August 9, 2023

Subject line: Illegal lot line adjustments/"split-lot subdivision," Expanded Housing Option (EHO) permits, and any building permits for 4015 & 4019 7<sup>th</sup> St S (Real Property Codes 23019030 and 23019029, respectively)

Re: Preliminary Subdivision Plat for 4015 & 4019 7<sup>th</sup> St S

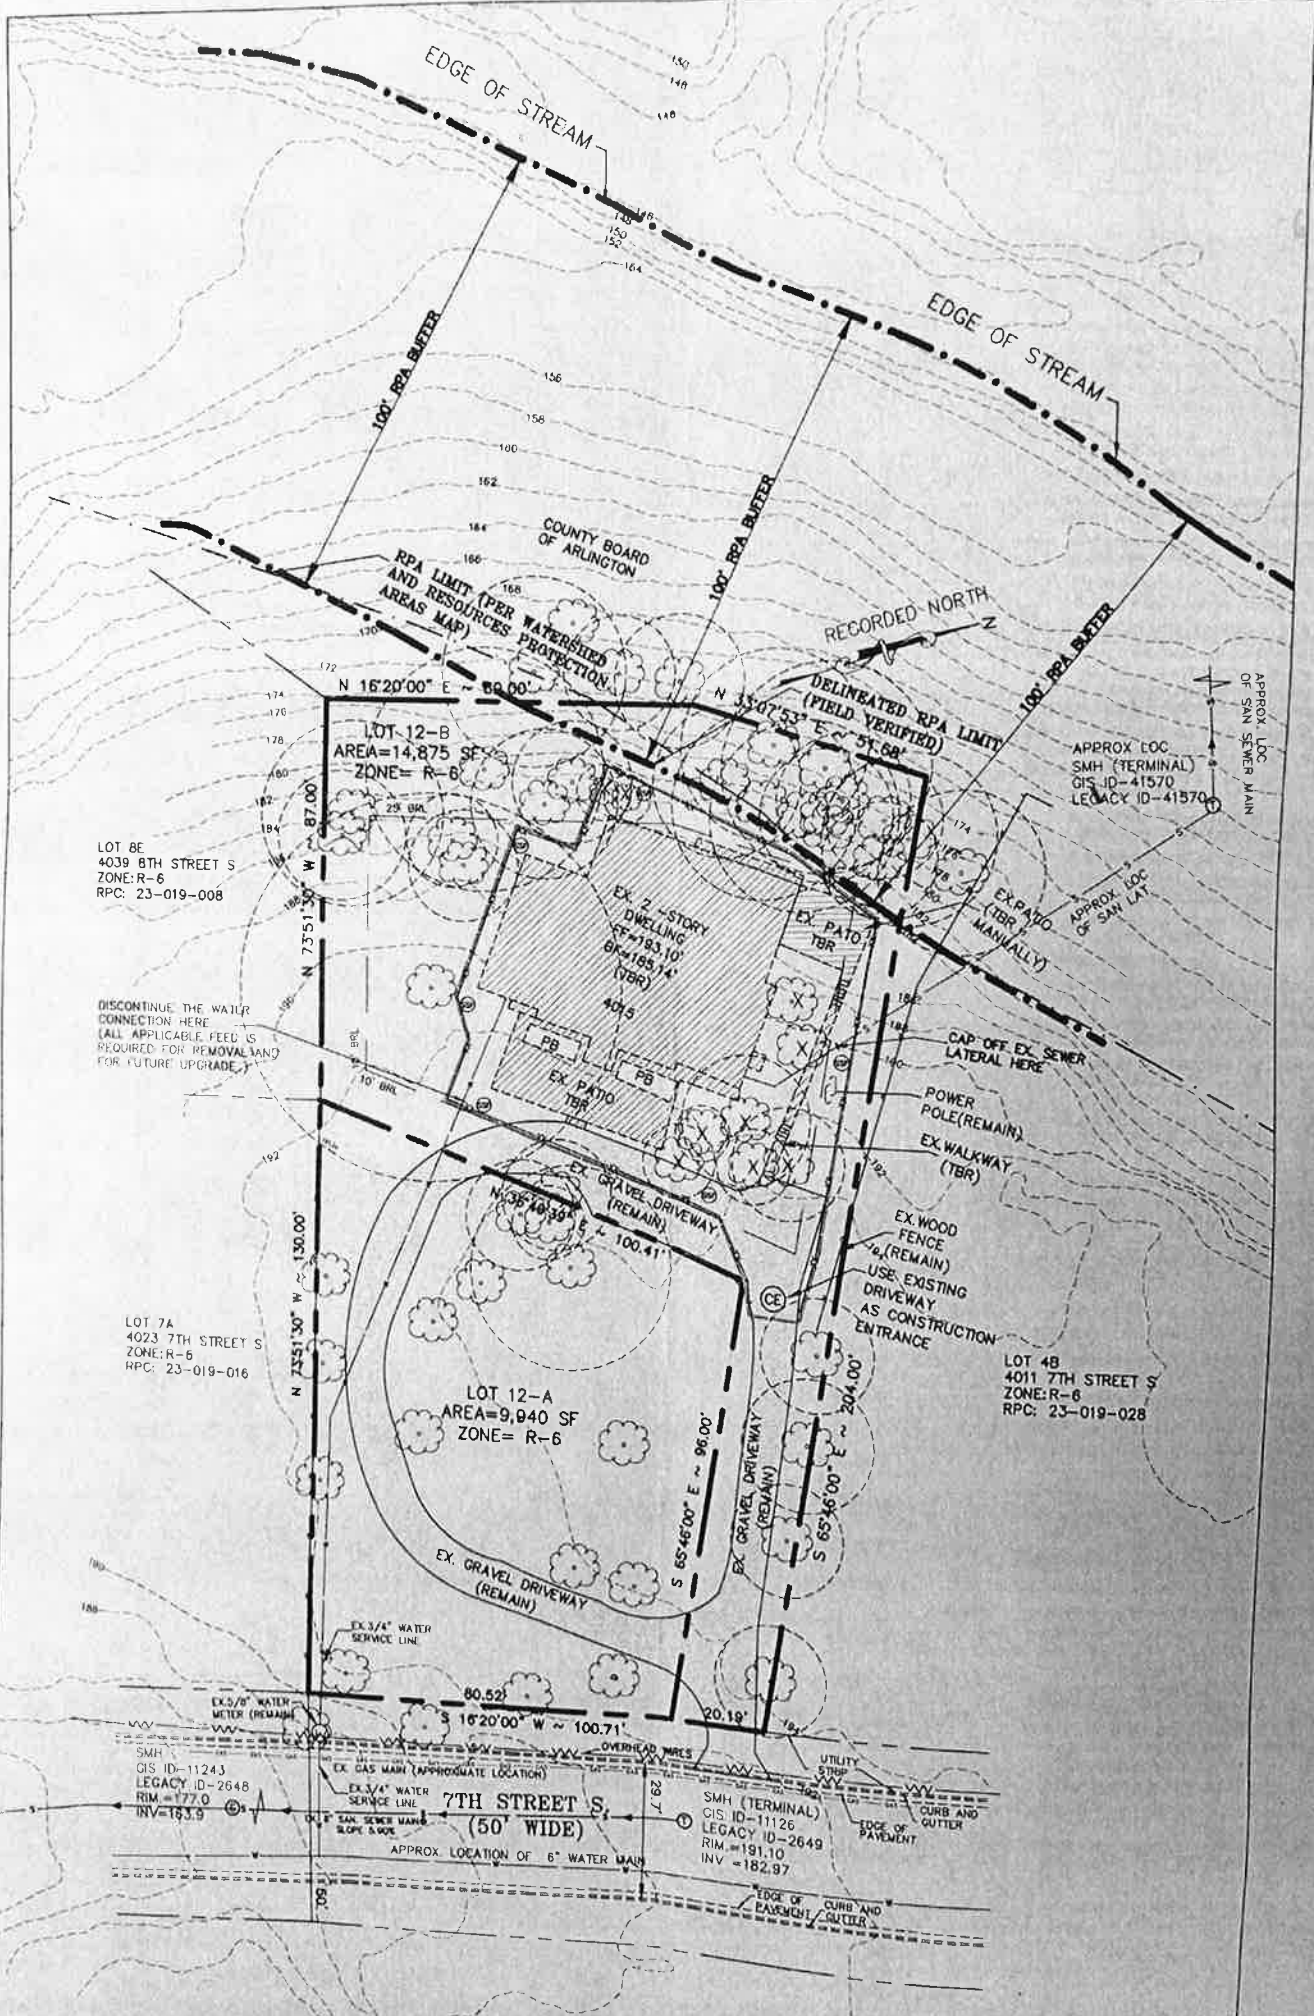
**1. Illegal Split-lot Subdivision.** Regarding the proposed split-lot “subdivision” or lot line reconfiguration, the developer does not have a “by right” ability to reconfigure the two existing lots into a new configuration as a subdivision is not occurring despite what is being claimed. As a result, the developer’s current “subdivision” request may not be approved administratively by the zoning administrator. The Arlington County Zoning Ordinance is clear that split lots can be created from one previous lot, pursuant to §3.2.4.C.1.b. Hence, a split-lot subdivision occurs when two lots are created from one lot, which is consistent with the dictionary definition of dividing into smaller parts. In the case of 4015 and 4019 7<sup>th</sup> St S, there are already two existing lots, not one. The owner of two abutting lots is attempting to significantly alter the lot lines between each, under the guise of a split-lot subdivision. Thus, there is no legal subdivision being proposed, the developer has no “by right” authority to do this, and the zoning administrator may not approve this request under §3.2.4.C. We respectfully request information on any other existing zoning ordinance or real estate process for altering lot lines between two properties, including public engagement opportunities, county decision-makers, and county staff contact information.

**2. Incorrect Plats and Lot Measurements Used for Two EHO Applications.** Regarding the eligibility and legality of each EHO permit, an application based on an illegal subdivision should also render any EHO permit relying on these non-existent lot configurations and measurements moot and illegal. Enclosed are the current plats of the two properties, as provided by 4015 7<sup>th</sup> St S LLC for its demolition permit. The county should reject the two applications and invite the developer to apply for permits using the correct recorded plats, if desired.

**3. Failure to Meet EHO Requirements.** The permits—based on the questionably reconfigured lots—do not qualify for a multiplex since neither of the two EHO permits comply with the EHO’s minimum lot width. For a R-6 EHO development, the minimum lot width must be 60 feet for a multiplex, pursuant to §10.4.4 and as defined at §3.1.8. In the developer’s proposed split-lot/lot line reconfiguration, the width of the front lot line is only 50.35 feet and the middle point—based on the developer’s drawings, which we have not yet independently verified for accuracy—is only 57.67 feet. This is less than 60 feet. The Arlington County Zoning Ordinance is clear that the Board of Zoning Appeals does not have the authority to grant a use/variance permit for EHO developments. §15.6.6 states, *“The Board of Zoning Appeals shall not grant use permits to modify requirements for expanded housing option development as set forth in §10.4.”*
